# UNITED STATES PATENT AND TRADEMARK OFFICE

10/814,204

<b>Office Action Summary</b>	<b>Application No.</b>	<b>Applicant(s)</b>	
	10/814,204	XIE, SHOUCHUN	
	<b>Examiner</b>	<b>Art Unit</b>	
	Drew J. Brown	3616

## DETAILED ACTION

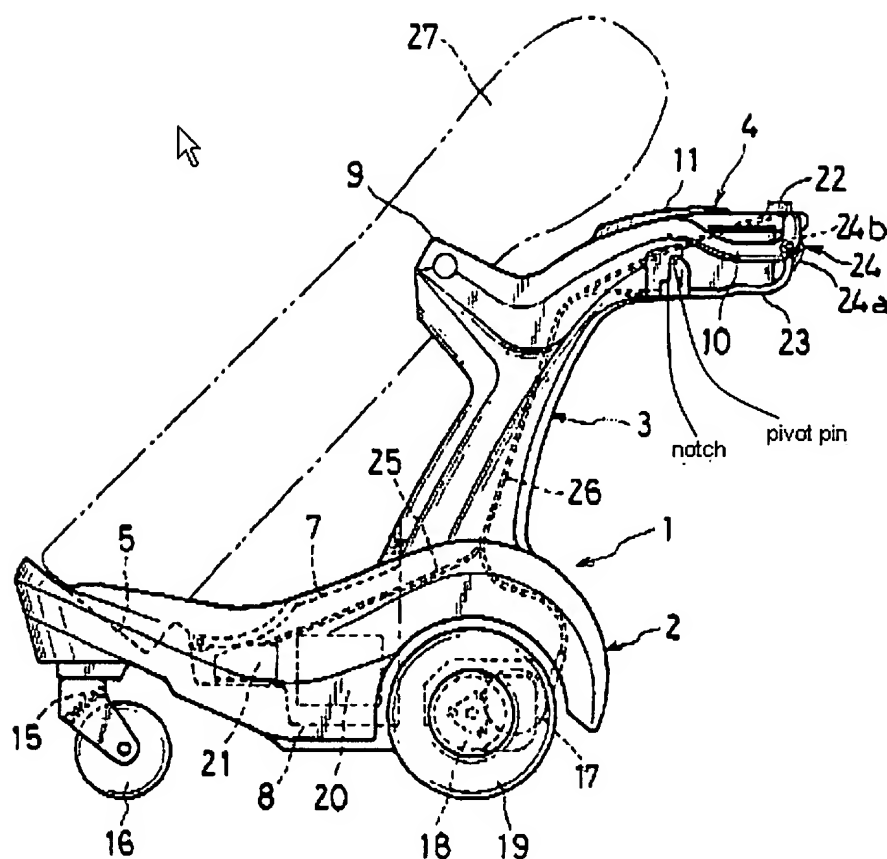
Furuta does disclose that the controller (21) is provided under the supporting platform (Figure 1), and that regenerated braking of the electrical hub is performed by an electrical control system (column 6, lines 52-63). Furuta also discloses a braking grip (23) that is provided on the handle frame and electrically connected with the left controller and the right controller. The braking grip has a first end thereof pivotally connected with a fixing seat formed on one end of the handle frame via a pivot pin, and has a notch defined therein proximal to the first end thereof (as shown in the Figure below).

Therefore, it would have been obvious to one having ordinary skill in the art at the time the invention was made to modify the invention of Wang in view of the teachings of Furuta to provide the controller under the supporting platform in order to create more space above the platform for the occupant to stand, and also to protect it from being damaged due to inclement weather. It also would have been obvious to use an electrical control system for braking of the electric hub so additional braking elements are not needed, which would reduce the cost of manufacturing and also reduce the weight of the vehicle.
